ATTACHMENT 1

Comments

Subject: Draft Environmental Impact Statement (DEIS) for the Tehachapi Upland Multi-Species Habitat Conservation Plan, Kern and Los Angeles Counties, CA (CEQ # 20090011)

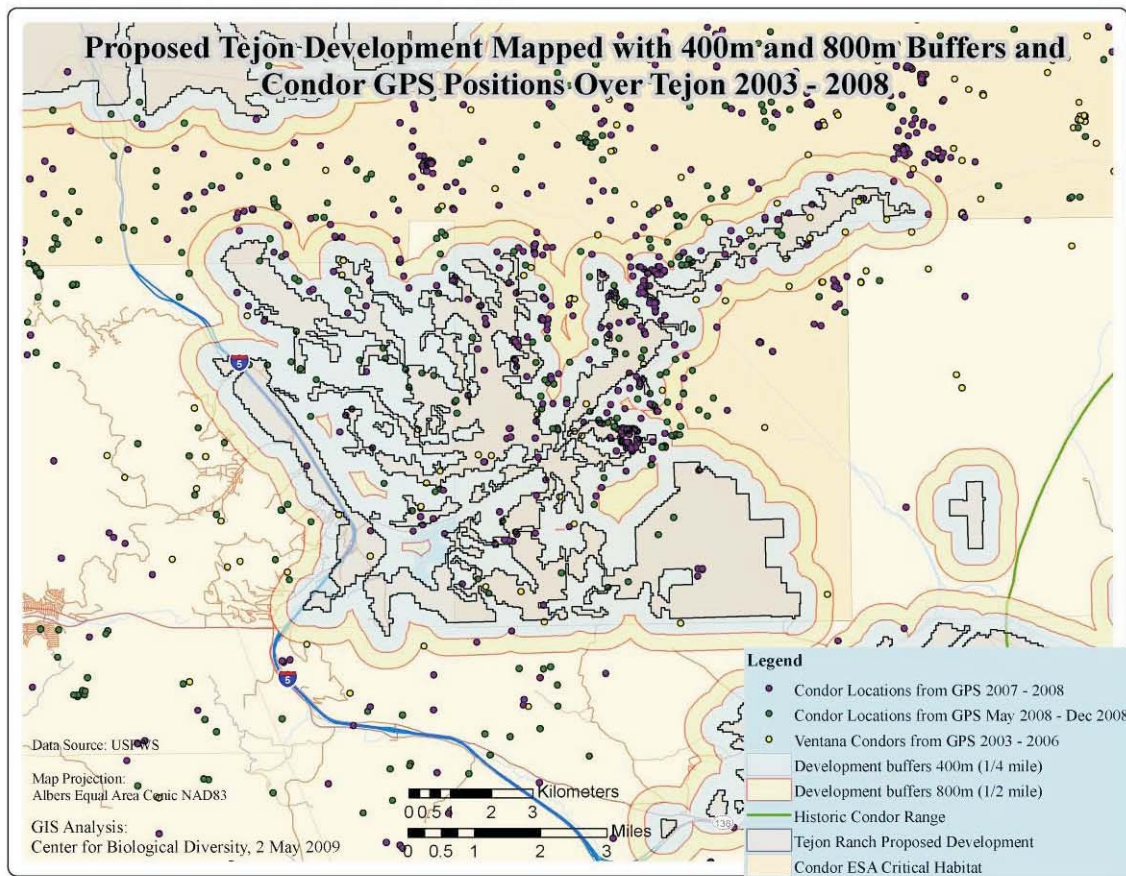
This is especially true, as described in Cogan's report, in a fragmented development scheme like TMV (Cogan 2009, Figure 15). The DHCP's failure to consider buffers for either the individual data points or for the development area thus renders its analysis and conclusions fatally flawed.⁵

3) The number of conflicts between designated critical habitat and condor data points is increased when environmental buffers are taken into account. In this figure the condor data points are represented as simple points for visual clarity, however these points should also be buffered into circles (as in Figure 14) to more accurately quantify impacts associated with development in critical habitat.
